Tippecanoe County Board of Commissioners

AGENDA

AIA® Document G701/CMa™ – 1992

PROJECT *(Name and address):*
885-Fairground Renovations
1406 Teal Rd.
Lafayette, IN 47905

Date 3/12/20 Project 885 - COLISEUM Sheet #

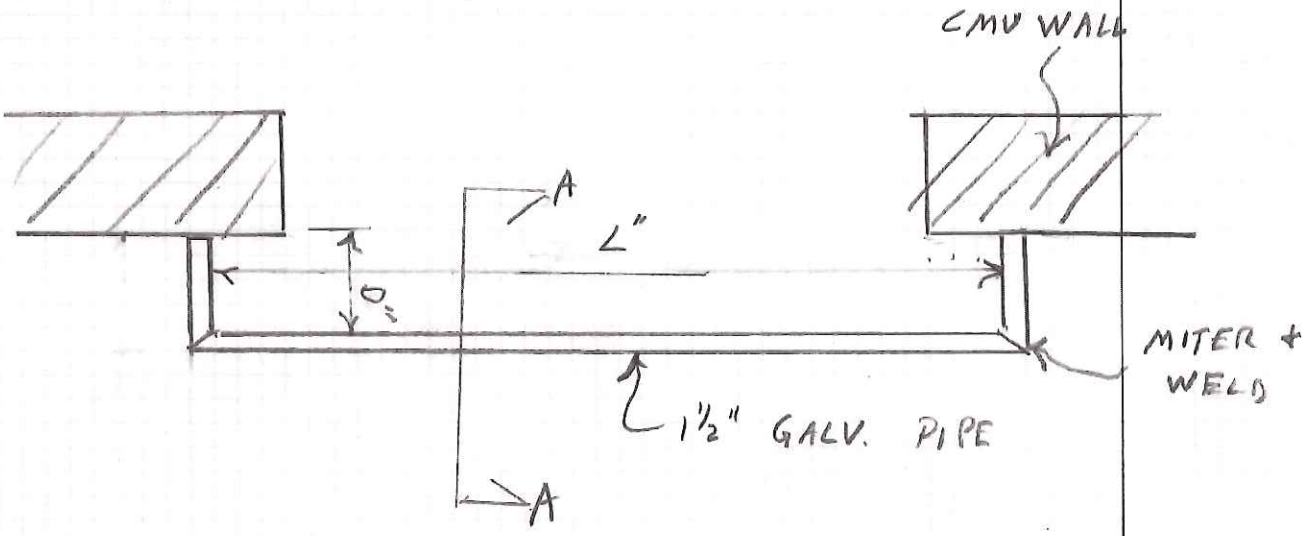
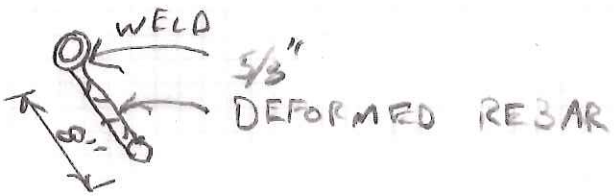
[] Add slab-on-grade 3/4" depression embeds at 6 ea. exterior overhead doors per attached detail.

@ OVERHEAD DOORS 106D, 119E - 126D

L = 24'-8"

D = 7"

@ OVERHEAD DOORS 124C, 125C + 126C, 137D, and 137C

L = 12'-8"

D = 6"
